*V0.95 SCH變更List note: 20190807 1.R39 修改為 1.24K 2.L4=3.3NH,C7=3.3NH		COMPANY: Siliten Electronics Co., Ltd TITLE: DM-8100(P705) Mouse MAIN SIZE: A2 NO: SHEET: 1 OF 1 DATE:2019/08/26 REV: V0.95

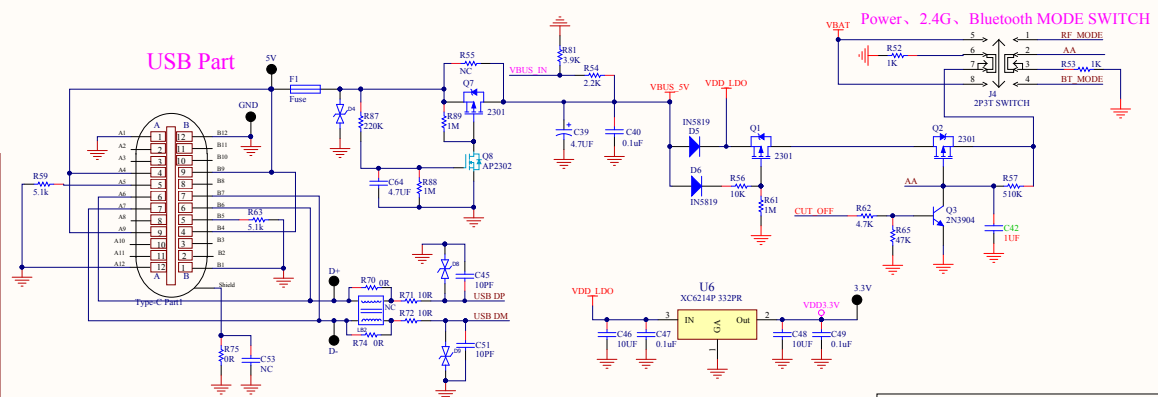
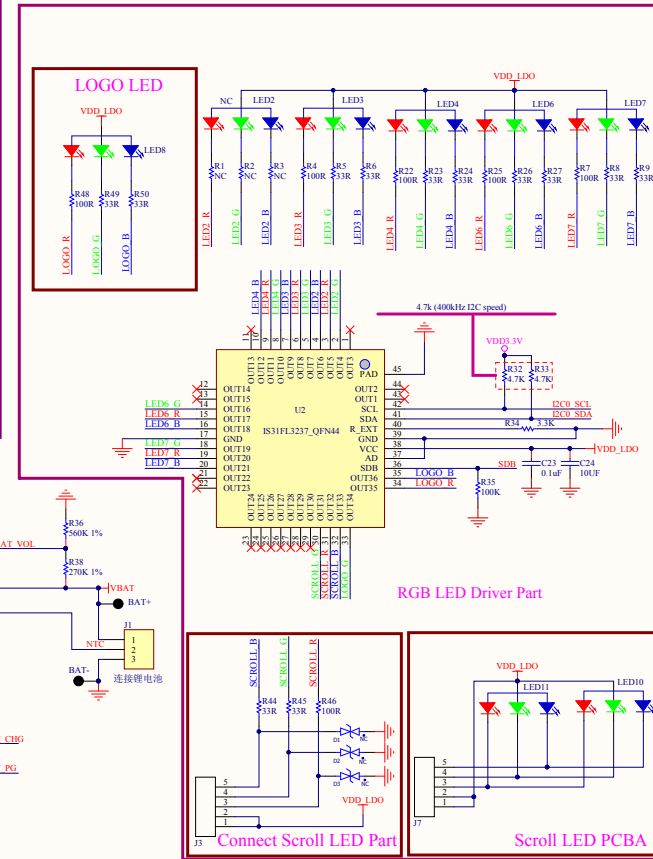
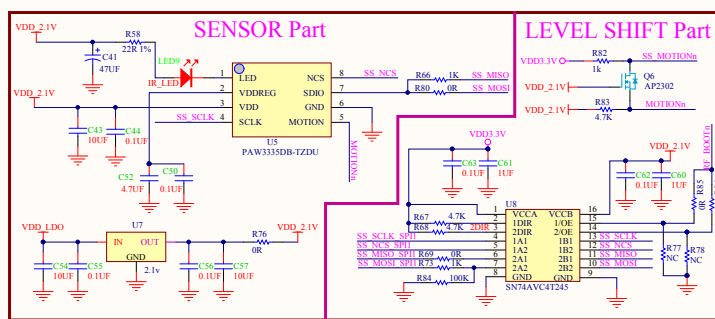
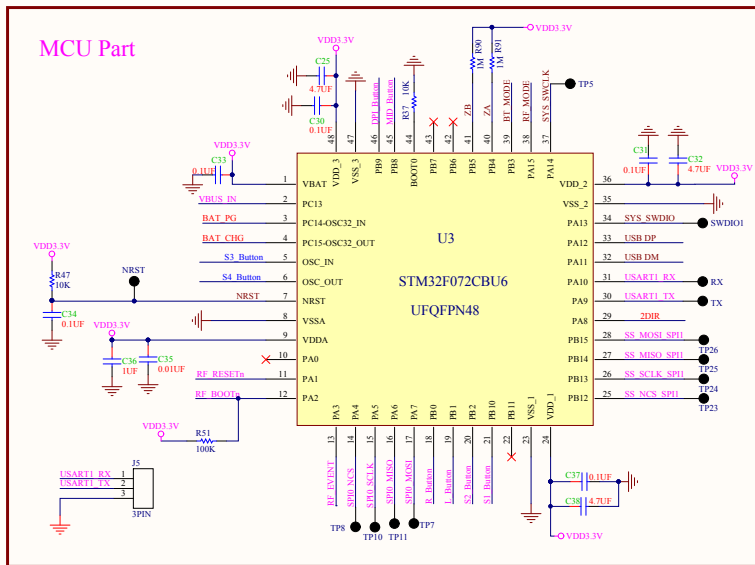
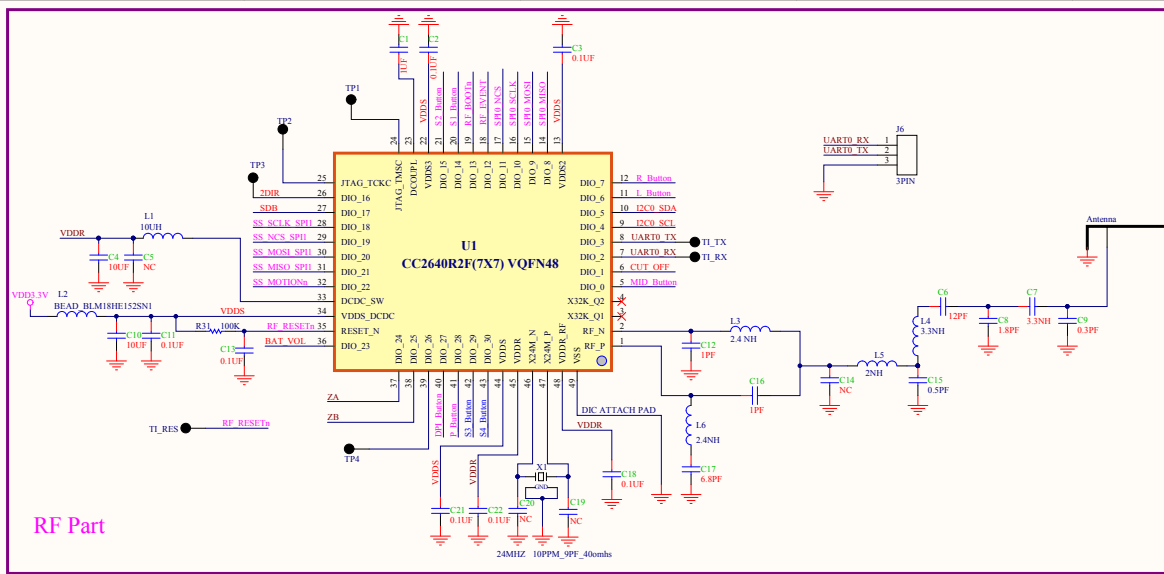
*V0.2 SCH變更List note: 20190410 1.修改R32/R33原來接VBUS_5V改接 VDD3.3V 2.修改LED1~LED8 原來接VBUS_5V為VDD_LDO 3.J3 1/2pin與U2 38pin原來接VBUS_5V為VDD_LDO 4.電阻R44 100R 修改為 33R,網絡由 SCROLL_R 接 SCROLL_B 5.電阻R46 33R 修改為 100R,網絡由 SCROLL_B 接 SCROLL_G 6.增加電阻R77~R80阻值為 NC,各用 7.網絡 ZA/ZB 線上增加電容 C58 1nF, C59 1nF 8.U1 18pin 接 U3 13pin 網絡名 RF_EVENT 9.U1/U3 14/15/16/17pin 網絡名由原來的 SIP1 改為 SPI0 10.U3 56pin 網絡刪除 11.U3 42/43pin 接網絡S3_Button/S4_Button 12.C2/C3/C18/C21/C22 電容由原來 22UF 修改為 0.1UF 13.C5 電容由原來 0.1UF 修改為 NC		*V0.3 SCH變更List note: 20190412 1.修改電阻 R57 由原來的 20K 改為 51K	
*V0.4 SCH變更List note: 20190412 1.U3 刪除 42/43pin 網絡 S3_Button/S4_Button 2.U3 增加 56pin 網絡 S3_Button/S4_Button		*V0.5 SCH變更List note: 20190508 1.U2 366pin 與 U1 27pin 增加 O6、RA10,RA11 電路 2.R64/R66 修改為 470K、R67 修改為 NC、R79 改為 10K 3.R55 改為 0R 電阻、R39 為 1.5K, C39 改為 4.7UF 4.U2 11Pin ~ 13pin 網絡名稱調整、14~16pin,18~22pin NC 5.U1 35pin ~ 連接到 U3 11pin 6.刪除 LED6,LED7,R56,R67,R25,R26,R27 電阻

*V0.6 SCH變更List note: 20190510 1.R54 修改為 2.2K,增加 R81、修改滾輪 LED 名稱 LED10/11 2.刪除 RA10,RA11 Q5 電路,增加 R7~R9,R25~R27,LED6,LED7 3.刪除 R19,R20,R21,R28,R29,R30 電阻、刪除 LED1,LED5		*V0.7 SCH變更List note: 20190521 1.刪除 R60/R68/R69/R73/R77~R80 電阻、Q4,Q7 2.增加電平轉換電路 U8,C60,C61,R67 改為 10K	
*V0.8 SCH變更List note: 20190529 1.刪除 R60/R68/R69/R73/R77~R80 電阻、Q4,Q7		*V0.9 SCH變更List note: 20190601 1.刪除 TP6、U8 型號 TXS0104E 修改為 SN74AVC4T245 2.修改 LEVEL SHIFTER 電路與 SENSOR SPI 接線方式 3.增加 TP23~TP26,C66 改為 2NHL4 改為 0R、L5 改為 52.2NH	
*V0.91 SCH變更List note: 20190614 1.增加 R84,R85,R86 電阻,C7 修改為 2NH,C9 改為 0.3PF 2.C6 改為 12PF,L4,L5 改為 2NH,R76 改為 0R 3.增加 RF_BOOT1n 網絡連接到 R85,R86		*V0.92 SCH變更List note: 20190619 1.增加 Q7,Q8,R87~R89 電阻,C64 電路 2.R55 修改為 NC	
*V0.93 SCH變更List note: 20190710 1.R57 電阻修改為 510K、C42 修改為 1UF 2.R77/R78 修改為 NC,R55/R86 改為 0R,R39 改為 1.2K 3.增加 R90/R91 連接到 U3 40/41pin		*V0.94 SCH變更List note: 20190807 1.LED2/R1/R2/R3 修改為 NC 2.R39 修改為 1K 3.C15=0.5PF,L4=3NH,C8=1.8PF,C7=3NH
